Subject: Duke Energy Carolinas, LLC  
William States Lee III Nuclear Station - Docket Nos. 52-018 and 52-019  
AP1000 Combined License Application for the  
William States Lee III Nuclear Station Units 1 and 2  
Response to Request for Additional Information  
Ltr# WLG2008.10-08

Reference: Letter from J.M. Muir (NRC) to B.J. Dolan (Duke Energy), *Request for Additional Information Regarding the Environmental Review of the Combined License Application for William States Lee III Nuclear Station Units 1 and 2*, dated August 21, 2008

**Lee Nuclear Station Response to Request for Additional Information (RAI)**

Figure 1 - Cut from Figure 2.4-1 Ecological Type Map of the Lee Nuclear Site Rev 0

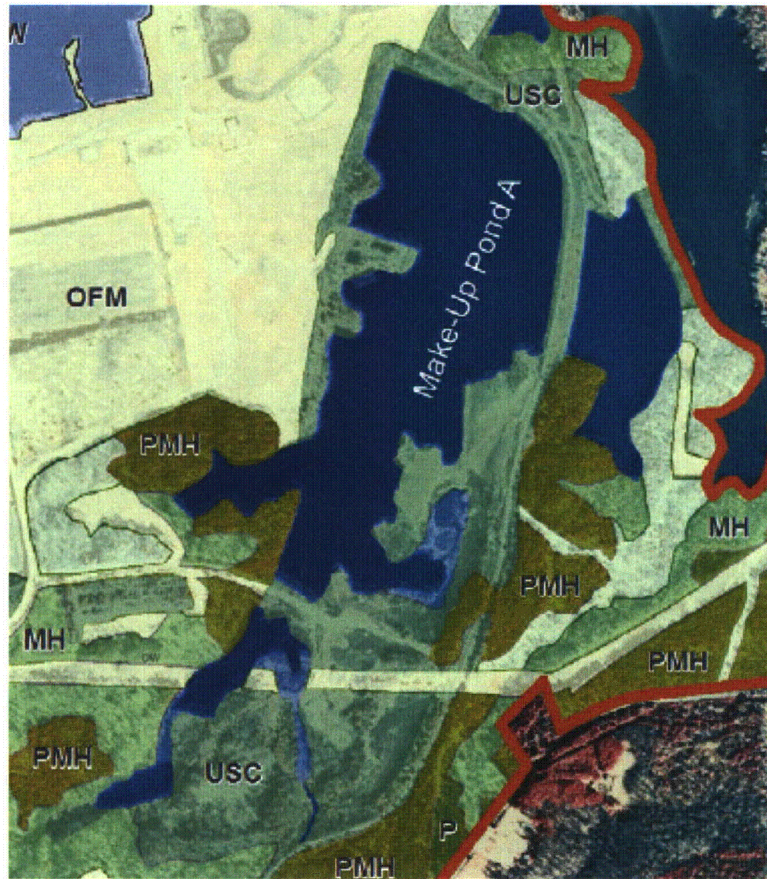
Are the ponds located just south of Make-up Pond A (see Environmental Report Figure 2.4-1) connected hydrologically to Make-up Pond A (e.g., via a culvert or semi-permeable material, etc.). If so, provide a bathymetric map with surface water elevations for these ponds. This is in relation to evaluating impacts to wetlands.

The area south of the Spoil Dam shown in Attachment 81-1, Figure 1 (taken from Environmental Report Figure 2.4-1) is in a natural draw that splits into two drainage arms and was used to spoil material during site work conducted in the late 1970s and early 1980s prior to the cancellation of the Cherokee Nuclear Project.

Based on 2006 high resolution aerial photographs and one-ft contour topography, there is currently approximately 29 ft difference (El 575.9- 546.7) between the ponded water south of the dam and the elevation of water in Make-up Pond A. The difference between these two levels leads to the conclusion that the spoil area is behaving as a "perched" water table with little or no connectivity between the two water levels. The spoil material is effectively acting as a liner and limiting the seepage to maintain a shallow pond fed by natural occurring inflows. Under these existing conditions, lowering the water level of Make-Up Pond A would not be expected to have any significant influence on the water level in the spoil area.
